August 9, 2019

RE: Adequacy Review 1 for 112 Construction Materials Reclamation Amendment 1 to the Permit, Bernhardt Gravel Mine, Permit M-2002-120; Response

This letter is being generated to satisfy the preliminary review dated June 4, 2019 for the Bernhardt Gravel Mine. The italicized items are the current comment and the bold text are the responses:

EXISTING
CONDITIONS/
MINING
PLAN

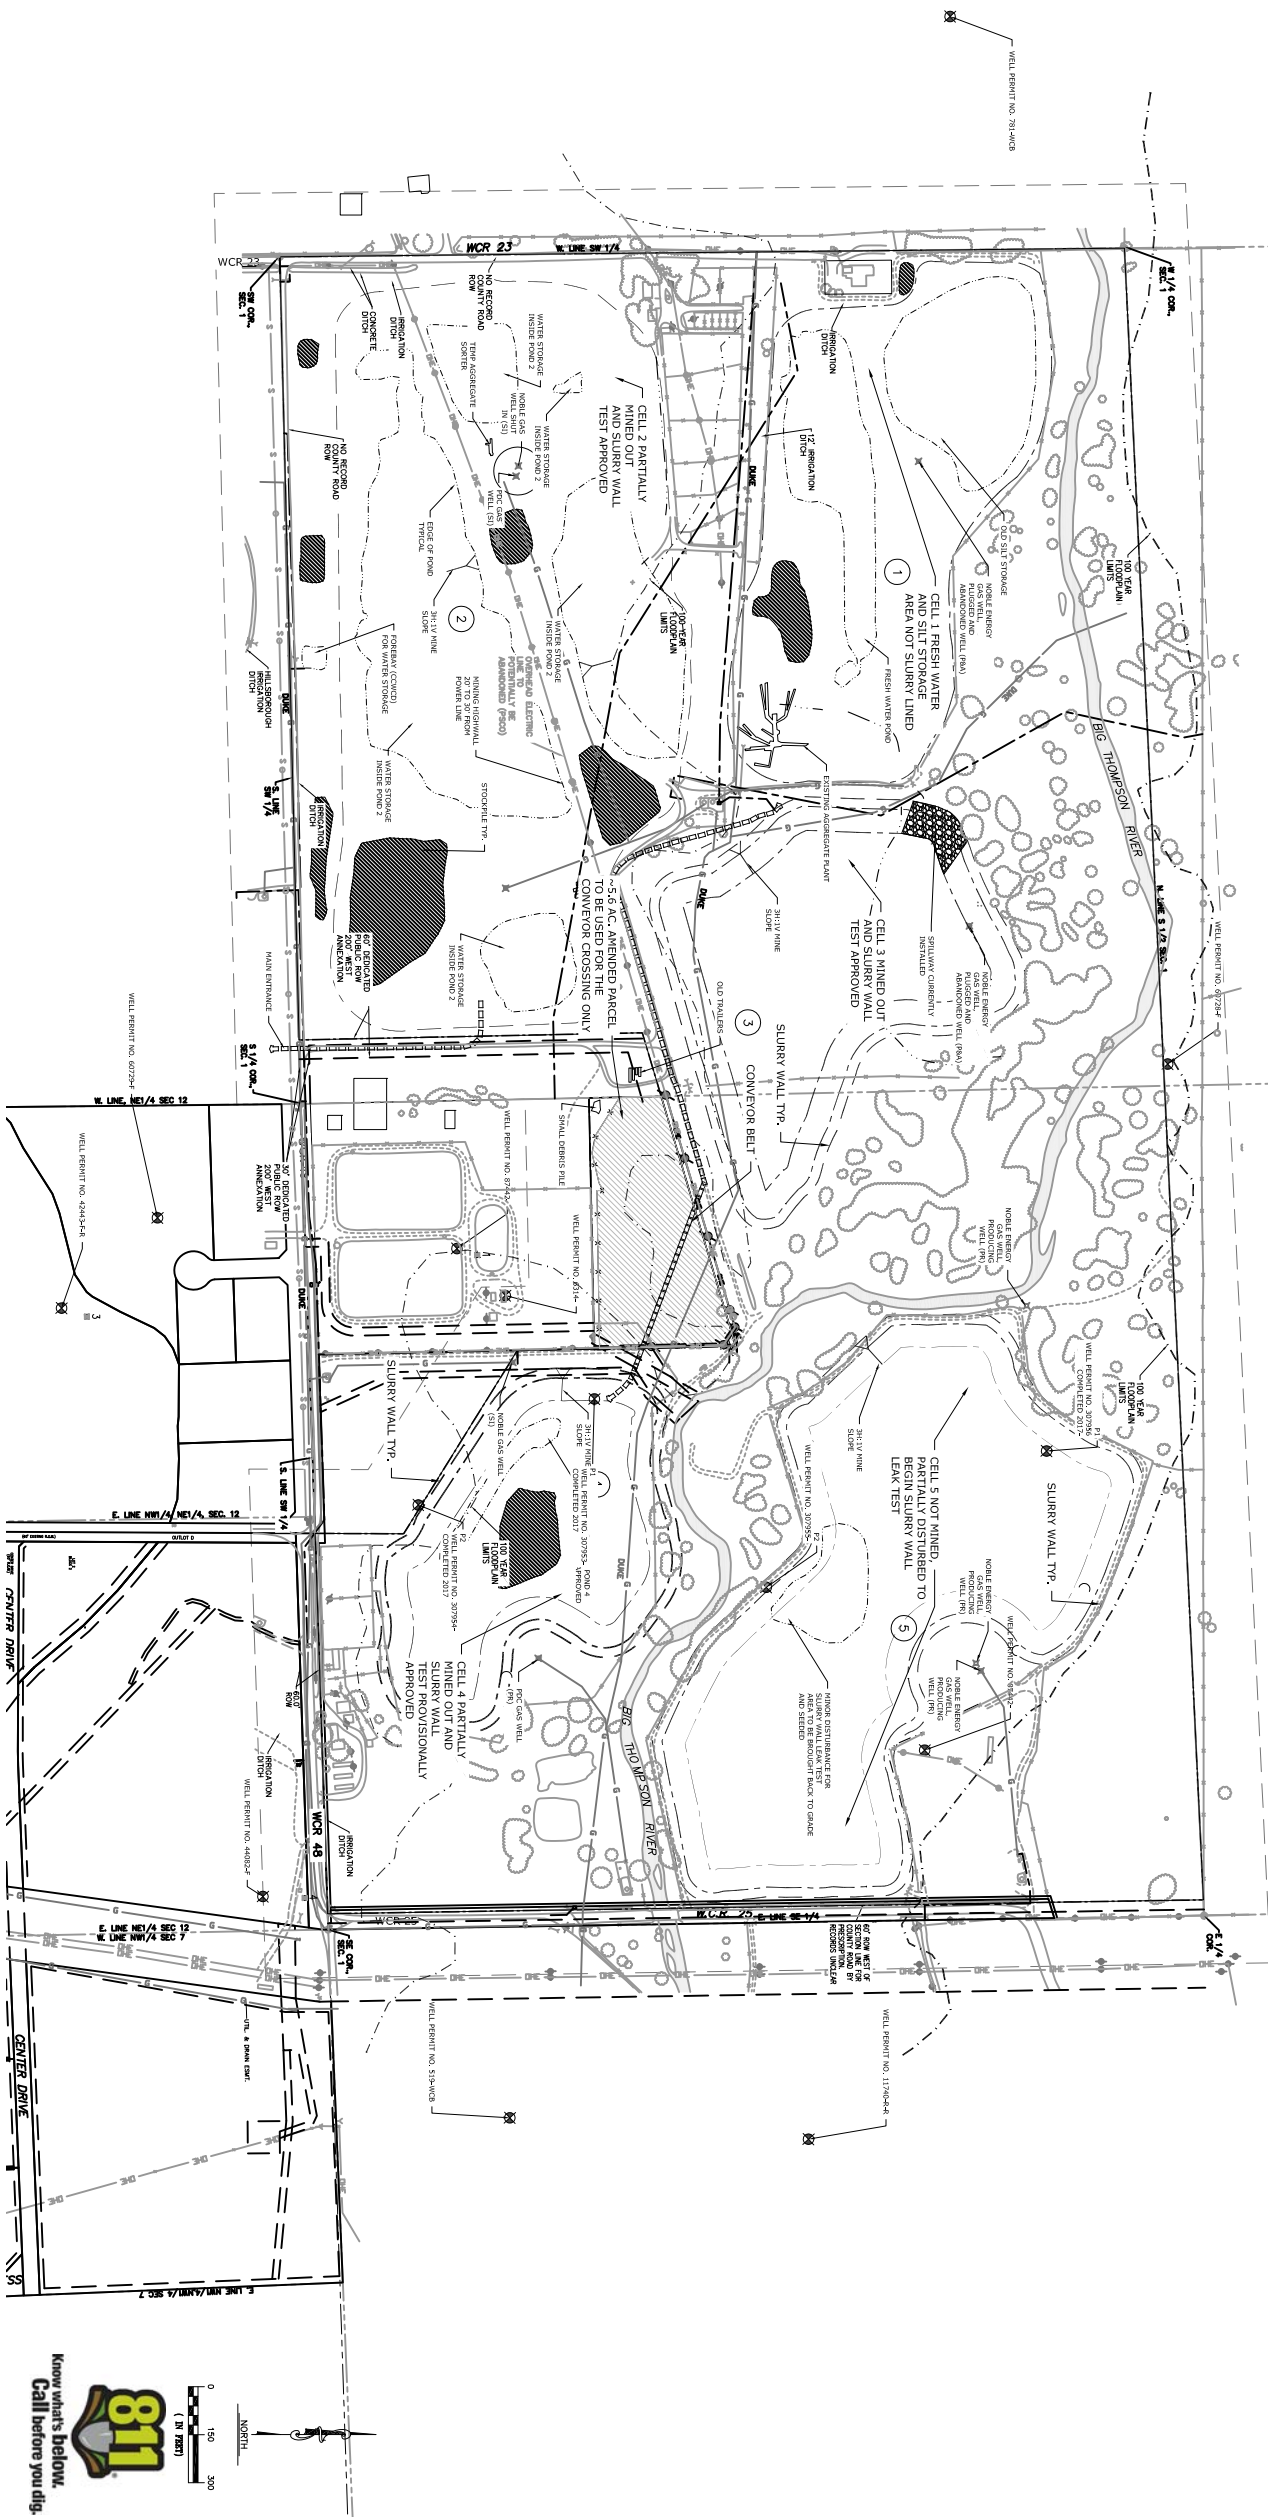
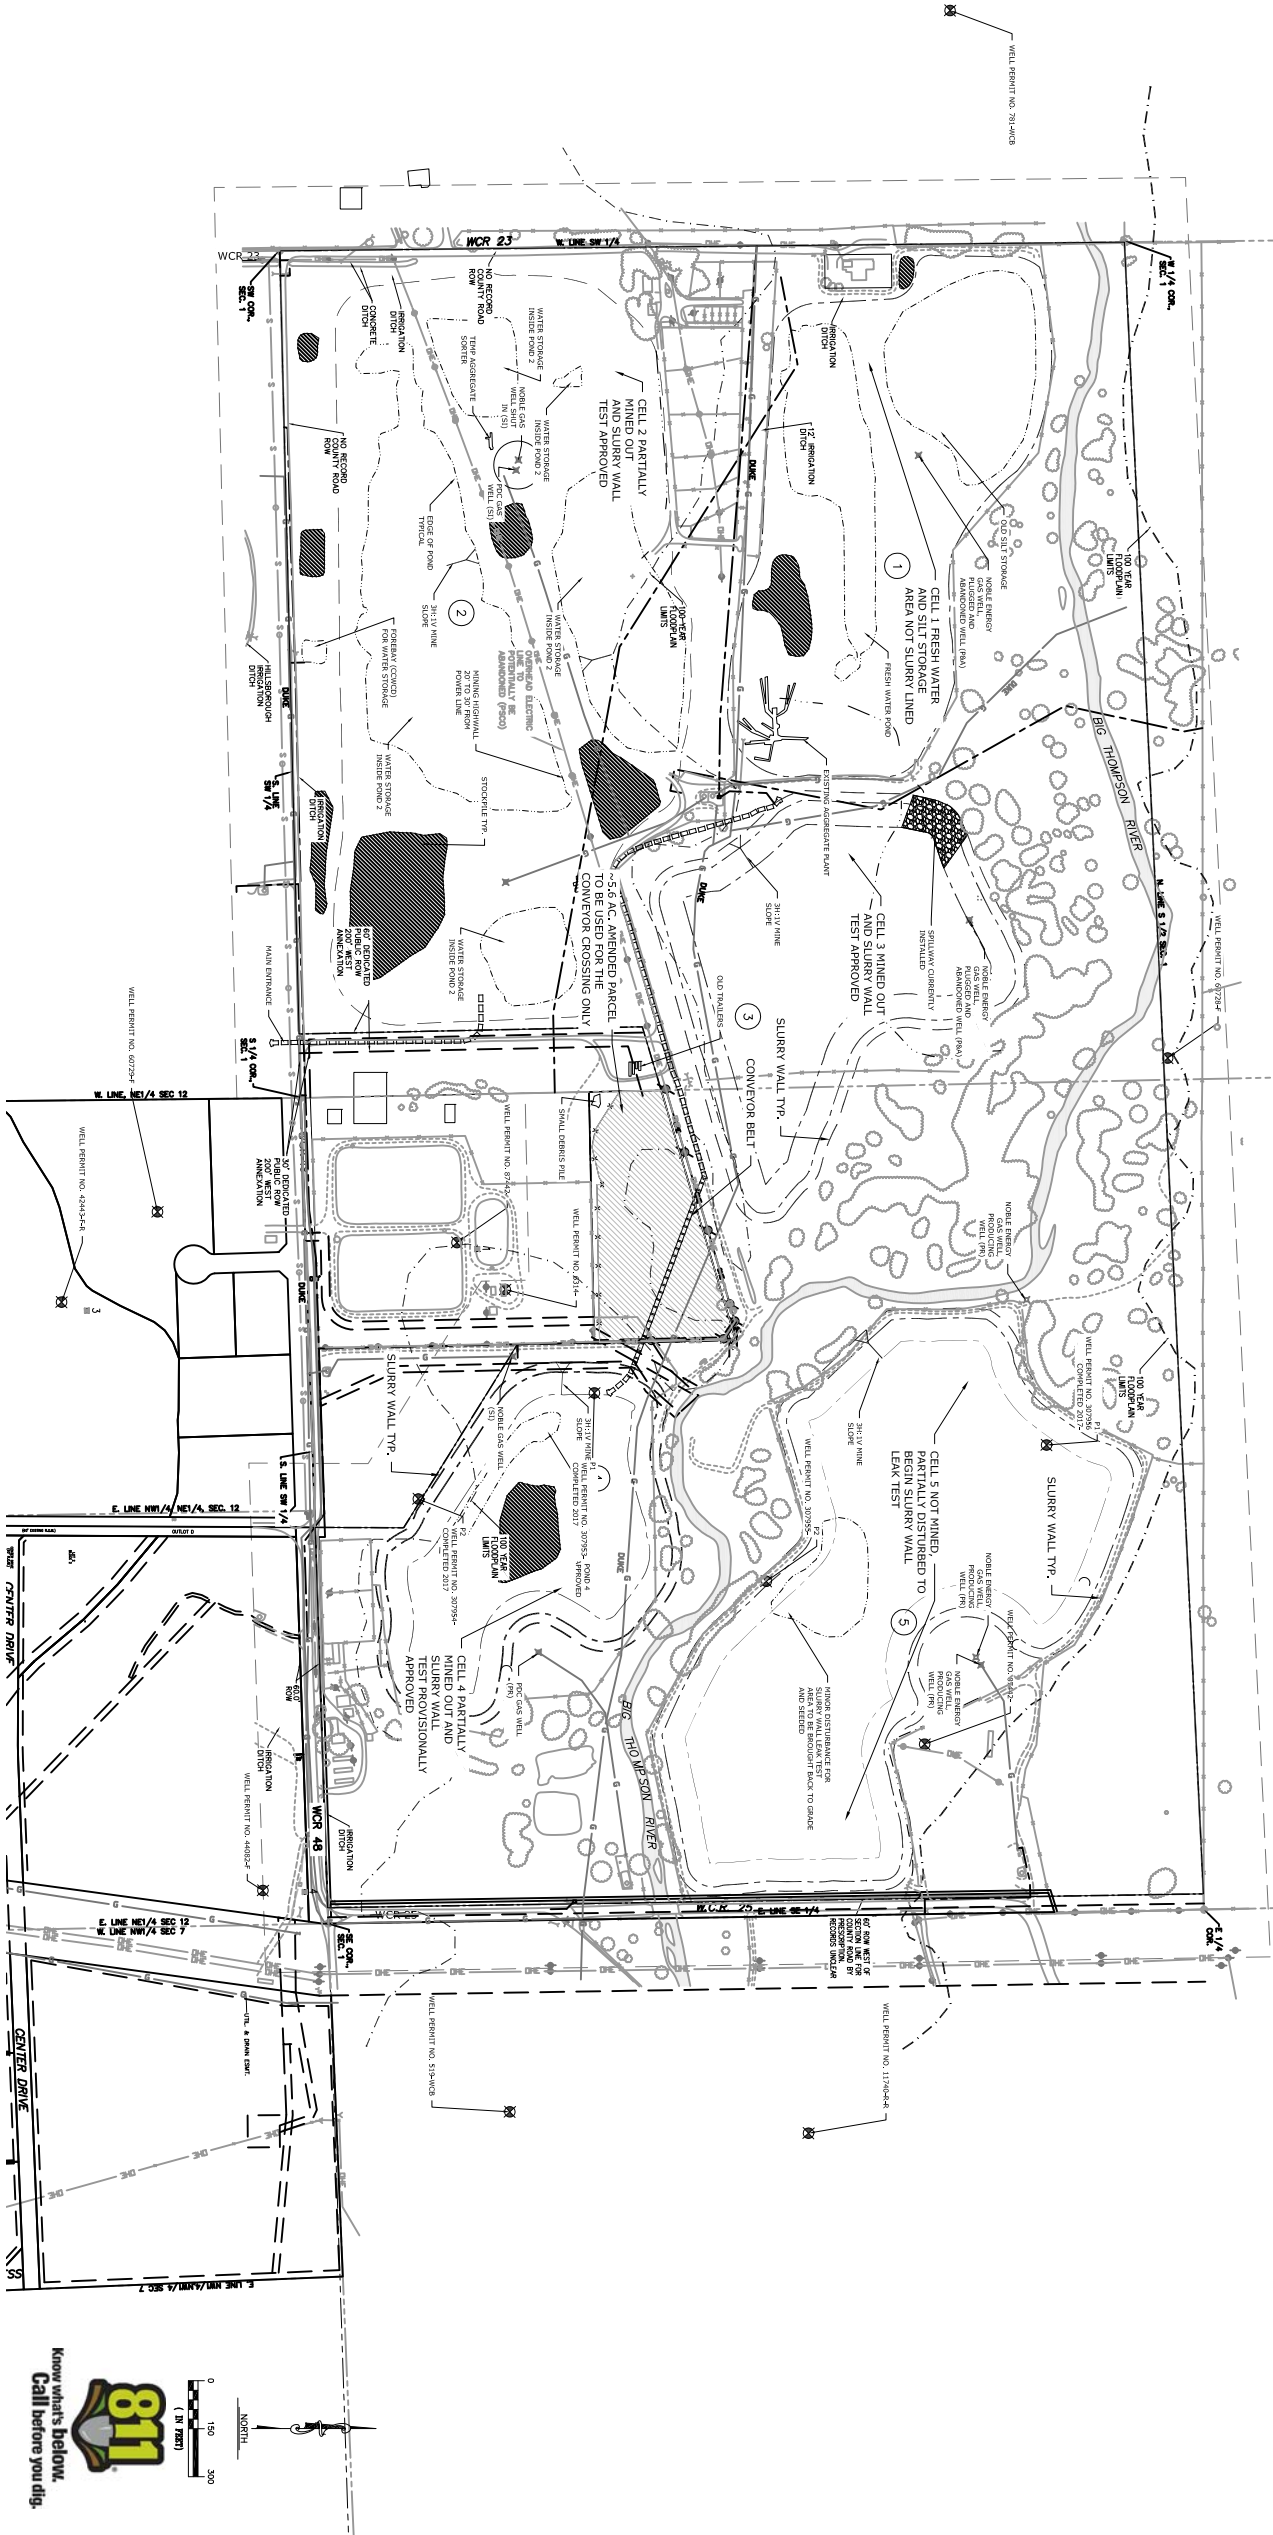
Property owner to the immediate SW of the permit (Vigil, Genevieve) has not been included. Also the property owner listed to the north of the permit area does not match the information on the Weld County Assessor's map, and a strip of property on the east side of the permit is not properly identified – Please update/revise as needed.

It appears that at least some gas/oil features have been removed/relocated (patina gas well in cell #3?) Please update maps as needed to accurately reflect current conditions. Also please show the locations of all mine features such the processing plant, product stockpiles, conveyor, etc.

Cell 2 is stated as being "mined out" in the text and on the provided map, but the existing configuration does not match the reclamation plan map. Please revise mine plan/reclamation plan to show additional mining and/or the proposed final configuration of Cell 2 when mining is complete (open water vs. upland). See updated map, but the amended area will be upland and the original permit boundary will be reclaimed water storage.

There is a phase "5A" shown on the mining plan map, but it is not addressed in the mining plan – please revise as necessary. This phase is also present on the reclamation plan map. Phase 5A is the same as Phase 5.

Due to the density of information currently on the Mining Plan map, it may improve map clarity to summarize the features listed in 2(a) on a separate map for this exhibit. The maps have been updated.

See updated map(s) including all the property owners.
